## HORSHAM DISTRICT COUNCIL CONSULTATION

| <b>LOCATION:</b>       | Land East of 1 To 25 Hayes Lane Slinfold West Sussex                                                                                                                                                                                                                                                                                                                                                                                       |
| <b>DESCRIPTION:</b>    | Outline application with all matters to be reserved except for access and layout, for the erection of 38no. dwellings, (including 13no. on-site affordable housing units), together with access from Hayes Lane, vehicle and cycle parking, landscaping, open space and play provision, sustainable drainage, <del>and</del> re-alignment of Public Right of Way No.3782, <a href="#">and land for a scout hut and associated parking.</a> |
| <b>REFERENCE:</b>      | DC/25/2006

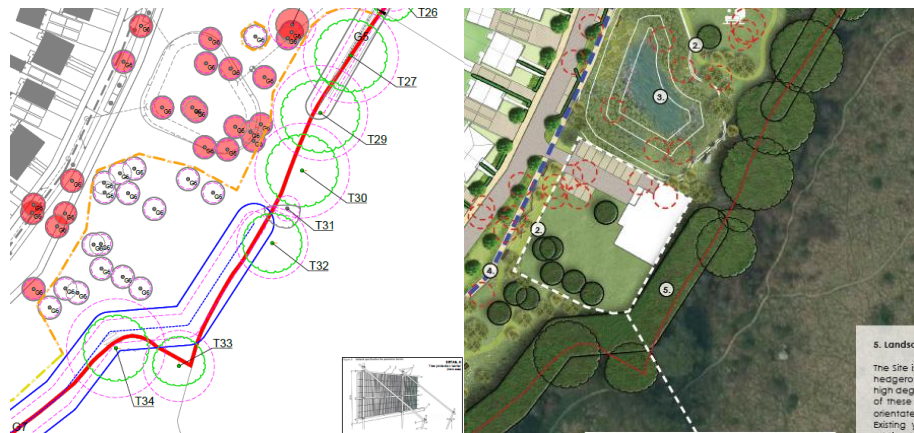
7. We note various instances of tandem parking in sets of 3. These should be a maximum of 2-aside to limit large areas of parked vehicles which are considered an urbanising detractor to the rural surrounds.

Not addressed. Please amend.
